Product Change Notification: P-20-020211

PCN Date: 22-DEC-20

General Product Description:
Composite 38999 Jam Nut Product

<p>Current Design Isometric View</p> 	<p>Current Design Side View</p> 
<p>New Design Isometric View</p> 	<p>New Design Side View</p>

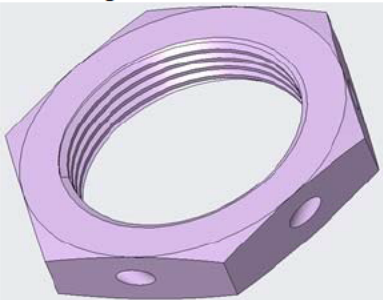
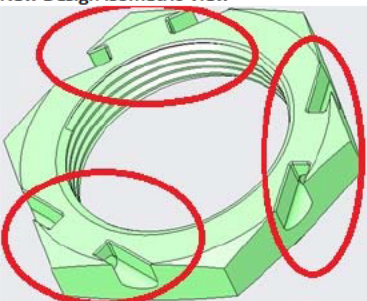
Description of Changes
TE would like to inform you of the following change(s) to the listed TE Connectivity product. In case of any further questions about this change(s), please contact your TE Connectivity Sales Engineer. Affected part, drawing and/or specification numbers are listed on the attached sheet. Panel nuts used on TE Connectivity's composite jam nuts will now feature a slot to provide the cross holes.

Reason for Changes:
Product improvement. New panel nut design will include slots to improve manufacturability.
